Major Projects New Request for Advice
Mixed Use Development – Samantha Riley Drive (SSD-99622708 & SSD-99622212)

I refer to your request for comments with respect to the above State Significant Developments SSD-99622708 and SSD-99622212 for the proposed mixed-use development, concurrent rezoning of land and early works at 301 Samantha Riley Drive, Kellyville.

ATTACHMENT 2 – DEVELOPMENT APPLICATION COMMENTS

STATE SIGNIFICANT DEVELOPMENT CONSULTATION MEETING NOTES

Figure 15 – PMF Flood Levels

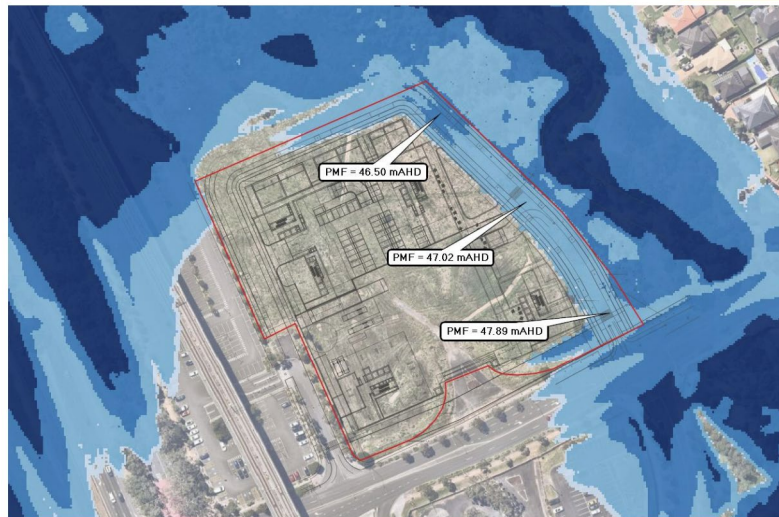
Subject to council' review of the flood models and confirming the flood behaviour (flood levels, depths, velocity and hazard) along the Elizabeth Elizabeth Macarthur Creek, the design of road profiles and the buildings must be ensured compliant of following relevant design controls and the recommendations of ATL report:

- The eastern and northern roads levels are set to a minimum 100mm higher than the 1% AEP flood level.

- The building levels are set to Flood Planning Level (FPL3), i.e 500mm above the 1% AEP flood level to protect from flood inundation.
- Given that the eastern road is inundated during Permissible Maximum Flood event (PMF), the driveway entrance from eastern road shall be considerate protection up to the PMF level.

Non-compliant road sections:

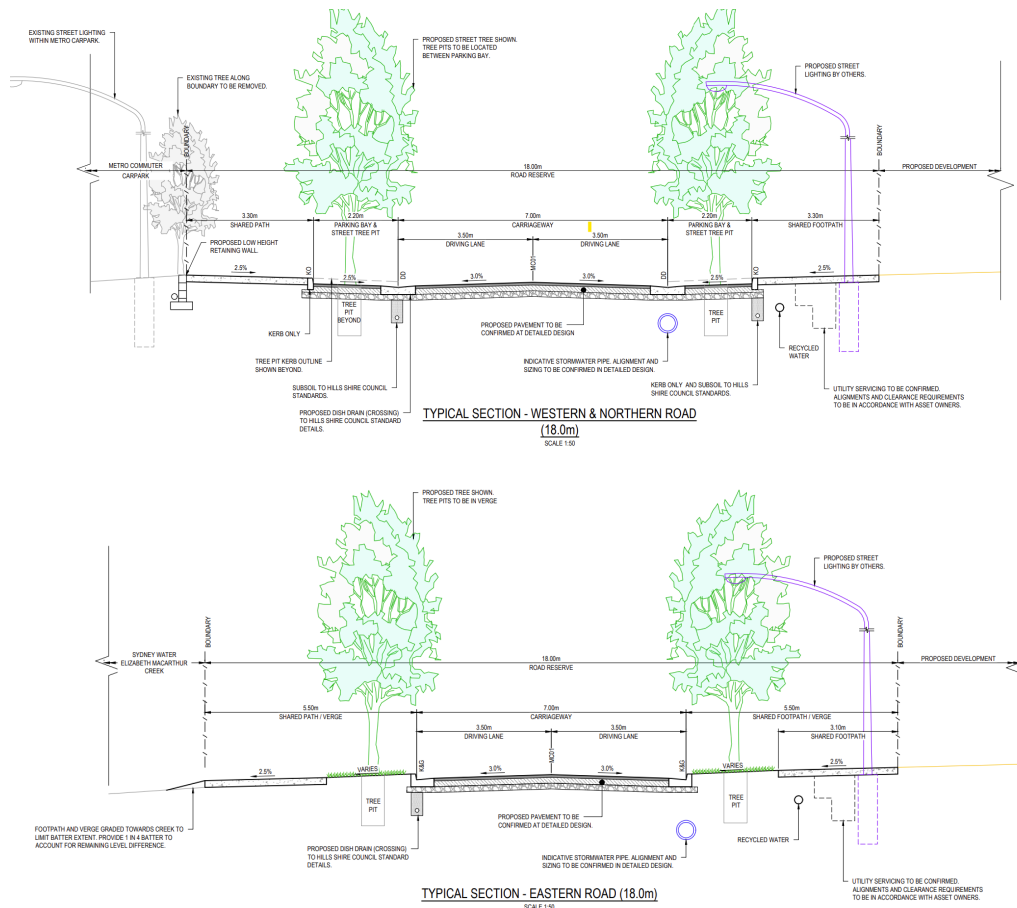
The 'SSD-99622708 - CIVIL WORKS PACKAGE' set of design drawing prepared by AT&L has been reviewed and requires a revised set of drawings ensuring that road configurations comply with council's design standards to facilitate comfortable driving for the road users, avoid confusion on public assets and support the ongoing maintenance of council's assets. The design compliance requires compliance of following public road standards in accordance with relevant DCP as advised at the pre-lodgement:

- (a) All three roads (eastern, northern and western) configuration must be revised to include 6m wide carriage way width, and 2.5m indented parking bay and 3.5m wide footpath verge on both sides within the 18m wide road reserve; the non-standard dimensions shown on the drawings do not comply with council's standards as advised at the pre-lodgement.
- (b) Civil plans and Architectural plans clearly illustrating the provision of indented parking bays and 2.5m wide shared path on the verge adjoining to the creek along the eastern road.
- (c) Longitudinal section of the entire loop road connecting both ends of Samantha Riley Drive and adequate cross-sections ensuring the design compliance against flood control and vertical and horizontal geometry are required. It is advised that the minimum road gradient shall be 1% and the minimum vertical curve to be 25m.

The road design including geometry, vertical profiles and horizontal alignments must be designed to comply with council's Design Guideline subdivision and Developments.
